**STAFF REPORT**

**Proposed Administrative Civil Liability  
Contained in Complaint No. R9-2009-0026  
For the County of Riverside  
Regarding their Municipal Separate Storm Sewer System**

**Noncompliance with  
Order No. R9-2004-001  
Waste Discharge Requirements for  
Discharges of Urban Runoff from the  
Municipal Separate Storm Sewer Systems (MS4s)  
Draining the County of Riverside,  
the City of Murrieta, the City of Temecula and the  
Riverside County Flood Control and Water Conservation District  
within the San Diego Region**

**December 10, 2009**

Figure 8. Bioswale 11 on Briggs St. looking upstream

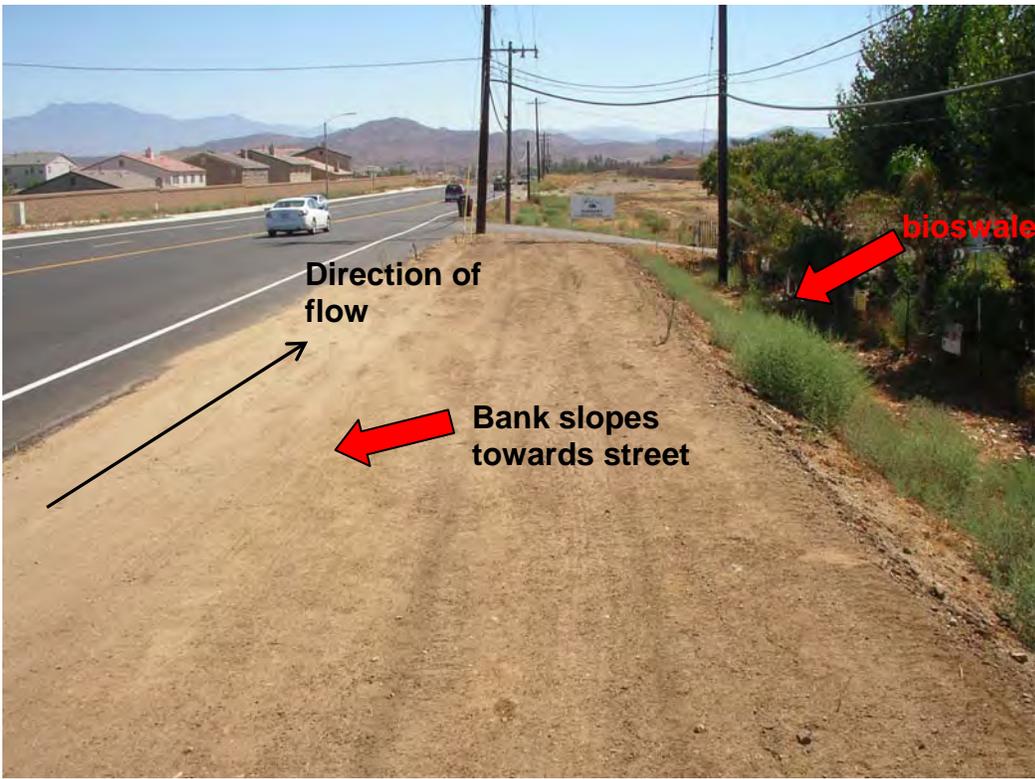
Figures 1 and 2 show bioswales on the north side of Scott Road, just east of Mira Lane. Figures 3 and 4 show bioswales directly across Scott road on the south side. Figure 5 shows a bioswale on the corner of Briggs Road and Kona Gold north of Scott Road. In all cases, grasses needed for treatment of pollutants are not planted and/or not established. Tumbleweeds and other weeds have grown in the bioswales (these are not specified in the as-built plans). Figures 6-8 show bioswales on Briggs Road, roughly 400 feet south of Scott Road. In addition to the observations made at previous bioswales, both of these bioswales on Briggs Road are poorly graded and look more like gullies than functional bioswales. Figures 9-10 show a bioswale on the south side of Scott Road. Again, the bioswale and surrounding area are poorly graded and will not capture runoff from the street as intended.

Figures 11-12 show a storm drain inlet on the north side of Scott Road at Station 113+03.32. The inlet contains a catch basin that is in need of cleaning. The inlet does not have proper signage as indicated in the WQMP dated 12/24/08.

Figure 13 shows drainage and evidence of curbside erosion towards the final bioswale, located east of El Centro Lane. Figure 14 shows the bioswale at Station 125+00.00.
